Access Compliance Report Public Rights-of-Way (Curb Ramps)

Main Street: VIVIDO_ST		Cross Street: DANZA_ST		Location:	N
ADA ID: RPRK211116135749	Ramp Type: Type 4 - Parallel	Initial Pass/Fail: Fail	Overall Compliance: No	Severity Score:	15
Codes/Mitigation Info/Possible Solution			Field Measurements/Component Compliance

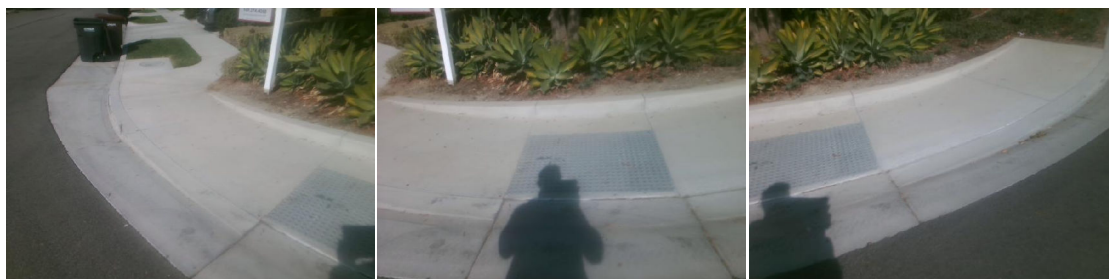
Compliance	Description	Data	Compliance	Description	Data
N/A	Ramp Length LT (in)	74	N/A	Ramp Length RT (in)	78
Yes	Ramp Width LT (in)	54	Yes	Ramp Width RT (in)	54
Yes	Ramp Run Slope LT (%)	2	No	Ramp Run Slope RT (%)	10.1
Yes	Ramp Cross Slope LT (%)	1.3	Yes	Ramp Cross Slope RT (%)	1
N/A	Landing Present	N/A	N/A	DWS Provided	N/A
N/A	Landing Length (in)	N/A	N/A	DWS Contrast	N/A
N/A	Landing Width (in)	N/A	N/A	DWS Length (in)	N/A
N/A	Landing Run Slope (%)	N/A	N/A	DWS Full Width	N/A
N/A	Landing Cross Slope (%)	N/A		DWS Offset Type	N/A
N/A	Landing Movement Obstructed?	N/A	N/A	DWS Offset Left (in)	N/A
	Landing Movement Type	N/A	N/A	DWS Offset Right (in)	N/A
N/A	Landing Shared	N/A			
N/A	Clear Space	Yes			
N/A	Clear Space To Crosswalk (in)	N/A			
N/A	Marked Crosswalk 1	No	N/A	Marked Crosswalk 2	No
	Crossing 1 Direction	SW		Crossing 2 Direction	SE
	Marked Crosswalk 1 Width (in)	N/A		Marked Crosswalk 2 Width (in)	N/A
N/A	Ramp Inside Crosswalk 1	N/A	N/A	Ramp Inside Crosswalk 2	N/A

Remove & Replace Curb Ramp With Two New Directional Ramps or Equivalent.
